CITY PLAN COMMISSION**THURSDAY, SEPTEMBER 18, 2025****FILE NUMBER:** PLAT-25-000080 (S245-230)**SENIOR PLANNER:** Hema Sharma**LOCATION:** bounded by Brentfield Drive, Meadowcreek Drive, LA Manga Drive and Shadybank Drive**DATE FILED:** August 21, 2025**ZONING:** PD 500**PD LINK:** <https://dallascityhall.com/departments/city-attorney/Articles/PDF/Article%20500.pdf>**CITY COUNCIL DISTRICT:** 12**SIZE OF REQUEST:** 19.8794-acres**APPLICANT/OWNER:** Richardson ISD

REQUEST: An application to replat a 19.8794-acre tract of land containing all of Lot 1 in City Block 27/8195 to create one lot and to dedicate easements and right-of-way on property bounded by Brentfield Drive, Meadowcreek Drive, LA Manga Drive and Shady Bank Road.

STAFF RECOMMENDATION: The request complies with the requirements of the PD 500; therefore, staff recommends approval of the request subject to compliance with the following conditions:

PRELIMINARY PLAT
OF
PJHS ADDITION
LOT 1, BLOCK 27/8195
REFPLAT
OP
PARKHILL SCHOOL ADDITION
BLOCK 27/8195
JOHN BECKELL, SURVEY, ABSTRACT NO. 53
CITY OF DALLAS, DALLAS COUNTY, TEXAS
CITY PLAT FILE NO. PLAT-55-000040 & S546-230
ENGINEERING NO. DP-_____
SCALE: 1" = 40'
DATE: MAY 2025

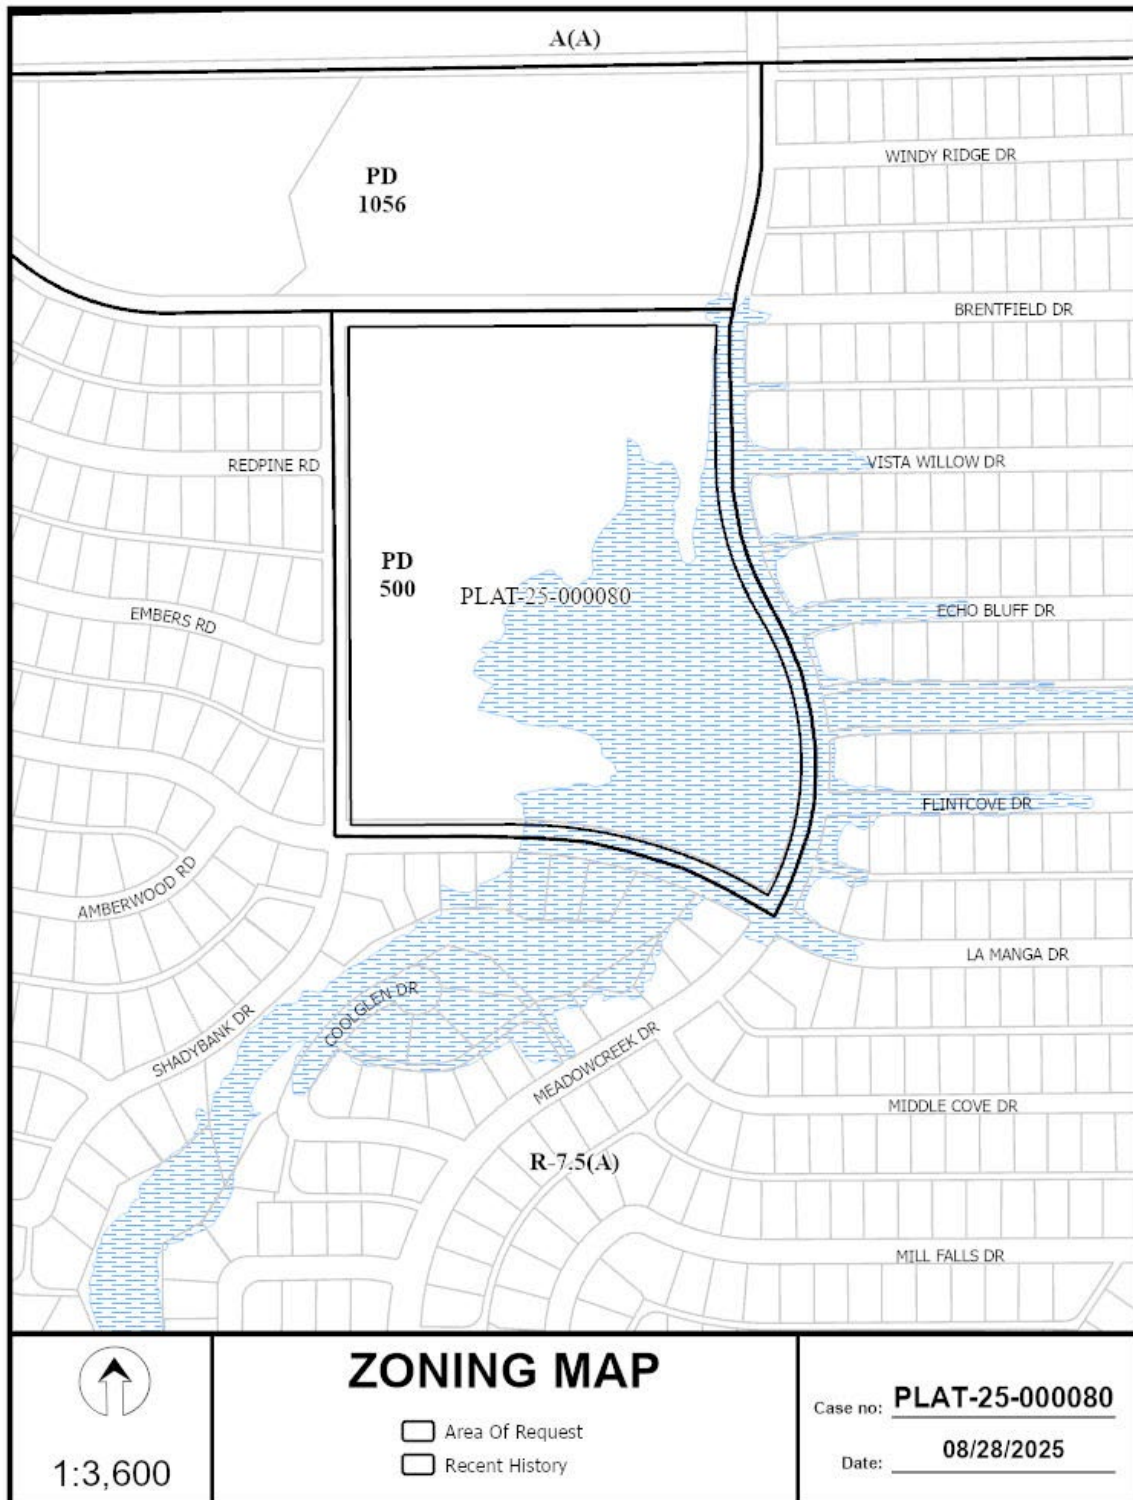
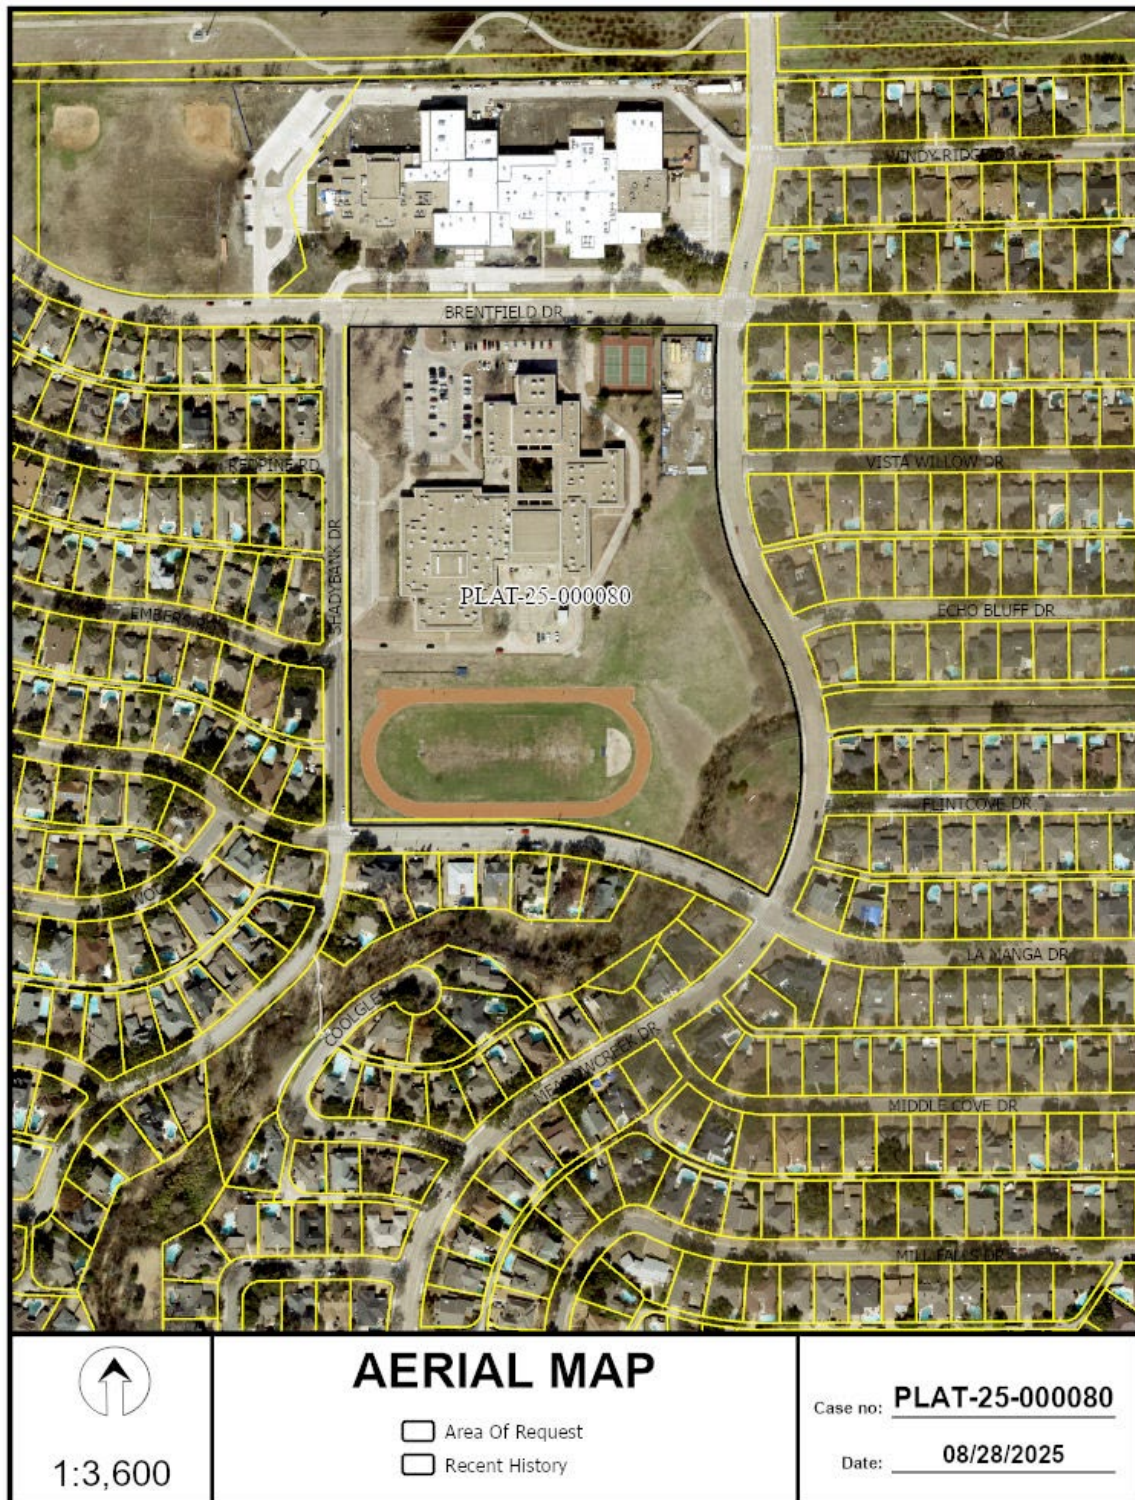
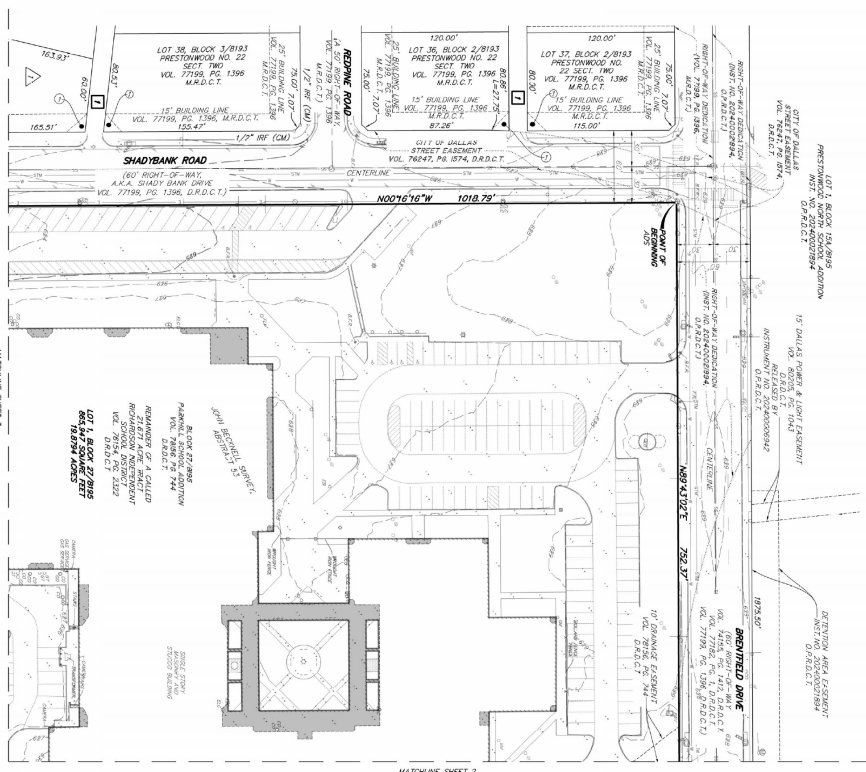
15. On the final plat, dedicate a minimum 5-foot by 5-foot corner clip (via fee simple or street easement) at the intersection of Shadybank Road & Brentfield Drive. Section 51A 8.602(d)(1).

16. On the final plat, dedicate a minimum 5-foot by 5-foot corner clip (via fee simple or street easement) at the intersection of LA Manga Drive & Shadybank Road. Section 51A 8.602(d)(1).

17. On the final plat, dedicate a minimum 5-foot by 5-foot corner clip (via fee simple or street easement) at the intersection of LA Manga Drive & Meadowcreek Drive. Section 51A 8.602(d)(1).

18. On the final plat, dedicate a minimum 5-foot by 5-foot corner clip (via fee simple or street easement) at the intersection of Brentfield Drive & Meadowcreek Drive. Section 51A 8.602(d)(1).

20. On the final plat, determine the 100-year water surface elevation across this addition.
21. On the final plat, dedicate floodway easement, floodway management area or floodway easement (within common area), with the appropriate easement statement included on the face of the Plat. 51A 8.611(d); DWU Floodplain Management; Drainage Design Manual Addendum V

23. On the final plat, specify minimum fill and minimum finished floor elevations. *Section 51A-8.611(d), Trinity Watershed Management.*
24. On the final plat, show the natural channel set back from the crest of the natural channel. *Section 51A-8.611(d), Trinity Watershed Management.*

29. Additional design information is required for assessment. Site plan must be submitted showing proposed development, building finished floor elevation, development, existing mains – including downstream manhole, and proposed water and wastewater service locations. Submit water/wastewater engineering plans to 320 E. Jefferson Blvd., Room 200, Attention: Water and Wastewater Engineering.
30. Wastewater main improvements may be required by Private Development Contract. Submit water/wastewater engineering plans to 320 E. Jefferson Blvd., Room 200, Attention: Water and Wastewater Engineering.

31. Prior to the final plat, remove fences in the right-of-way of Brentfield, Meadowcreek, and La Manga Drives and Shadybank Road and provide pictures and written documentation of the removal to Real Estate.
32. Prior to the final plat, contact Real Estate to process any abandonments needed.

33. On the final plat, change "Echo Bluff" to "Echo Bluff Drive". Section 51A-8.403(a)(1)(A)(xii).
34. On the final plat, change "Flintcove Drive" To "Flintcove Drive (AKA Flint Cove Drive)" Section 51A-8.403(a)(1)(A)(xii).
35. On the final plat, identify the property as Lot 1 in City Block 27A/8195.
